I have attached a list of amendments I would like to adjust on the BCDC Permit No. 2-02. The adjustments and changes made to the permit are separated into two parts, the first part are issues discussed between KSDG and BCDC. The second part of the changes are corrections to the permit due to error in jurisdictions stated and permit errors. The following list is the requested changes I would like to amend or eliminate:

Amendment No. 5 to 2002.002

Exhibit 1

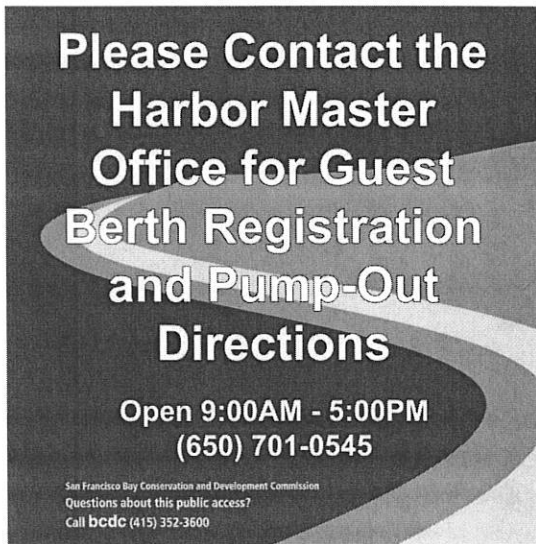
State sewage pump-out signage will be located at the Guest Berth; signage will direct guest boaters to the designated pump-out locations and the harbor master office for additional details. The sign will state "Please Contact the Harbor Master's Office for Guest Berth Registration and Pump-Out Directions, Open 9:00AM-5:00PM, (650) 701-0545". Due to the low usage of guest berths it is not practical to install sewage pump-out at the Guest Berth, however every other berth in the marina will have individual sewage pump-outs that can be used by Guest Boaters. See Exhibit 1 for sign.

Exhibit 2

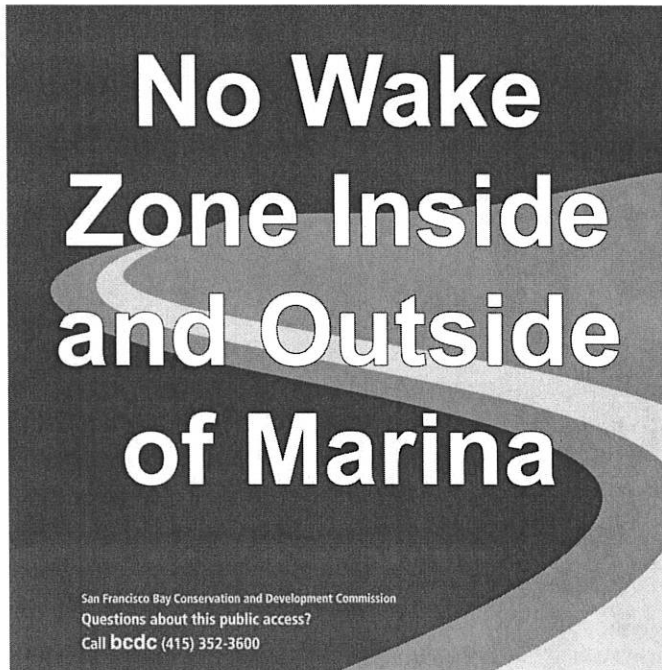
The permit states no wake buoys to be used, however the US Coast Guard and Port of Redwood City do not allow buoys to be used in navigable channels because the channels are too narrow to be safely used. We would like to amend the permit to reflect a "no wake" buoy placed in the harbor at the channel entrance by the Port of Redwood City, and two additional no wake signs mounted at the entrance to Westpoint Harbor as identified on the attached map see on Exhibit 2. As well, the existing requirement to place buoys in the navigation channel shall be changed to a requirement to instead place signs in that location (as already in place).

Add sign "No Wake Zone In and Outside Marina", see Exhibit 3 for sign.

# Exhibit 4

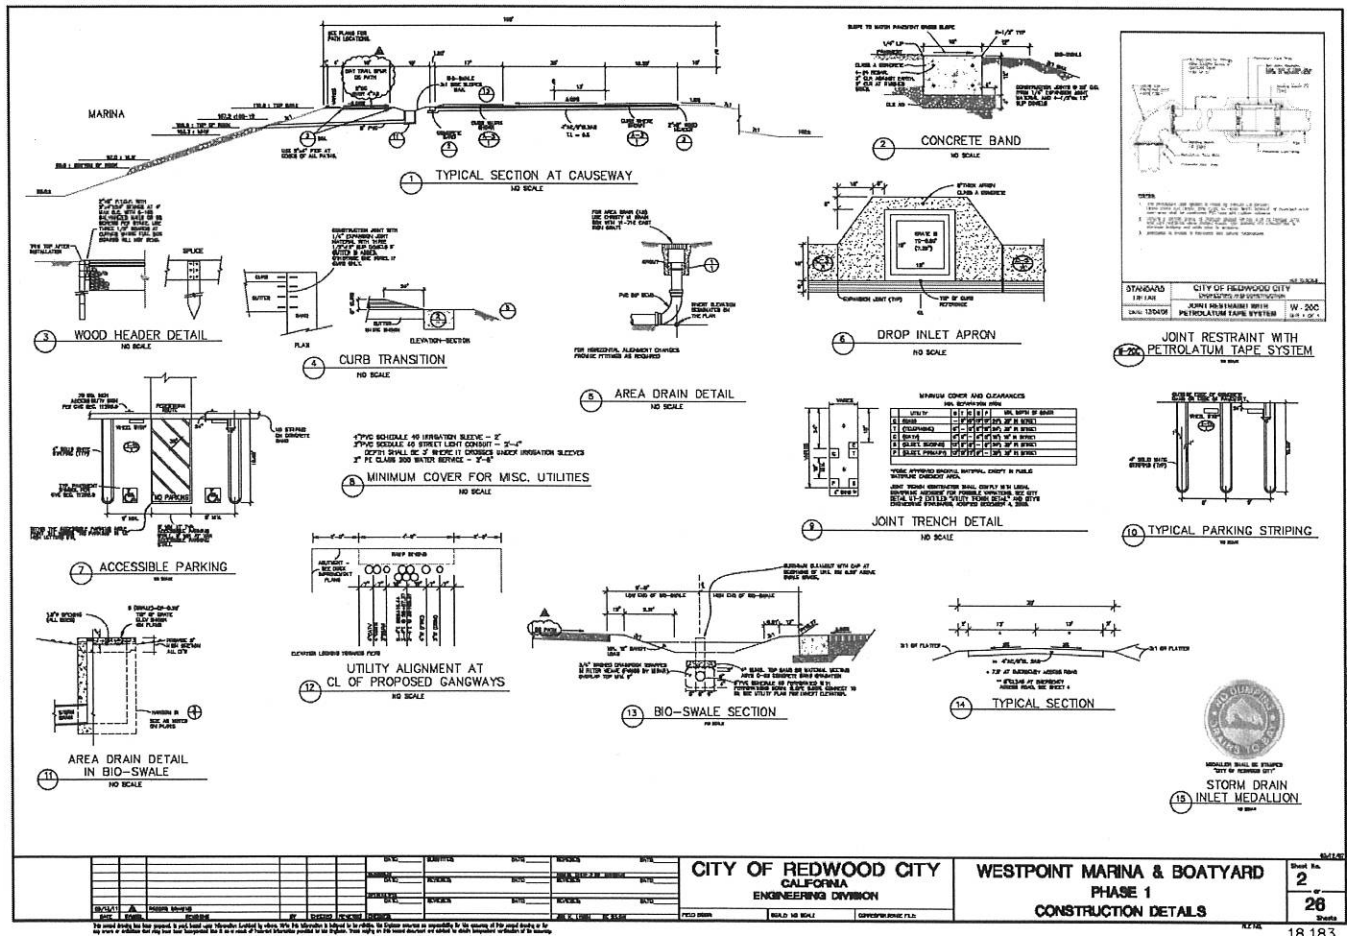
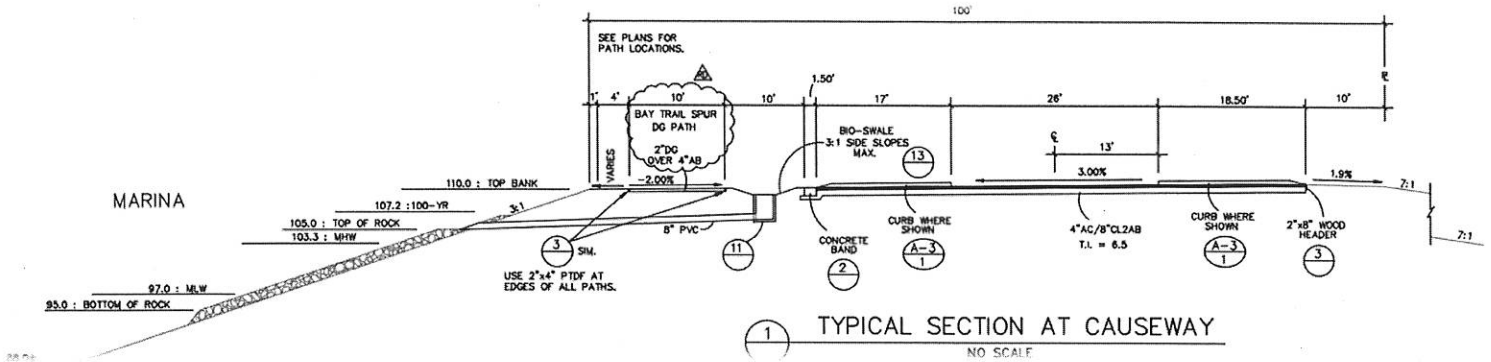
no Change "Twelve to Fifteen-foot-wide path" to 10 foot, pathways were changed to "ten feet wide" when DG was substituted for asphalt as shown on construction drawings. See Exhibit 4. For approved plan.

Amendment should read "decomposed granite with header-boards, and stone pavers at gangway entrances". (Pavers were necessary because of sand being tracked onto boats and are a permeable surface). Also, pathways were changed to "ten feet wide" when DG was substituted for asphalt as shown on construction drawings. See Exhibit 4. For approved plan of ten feet wide path.
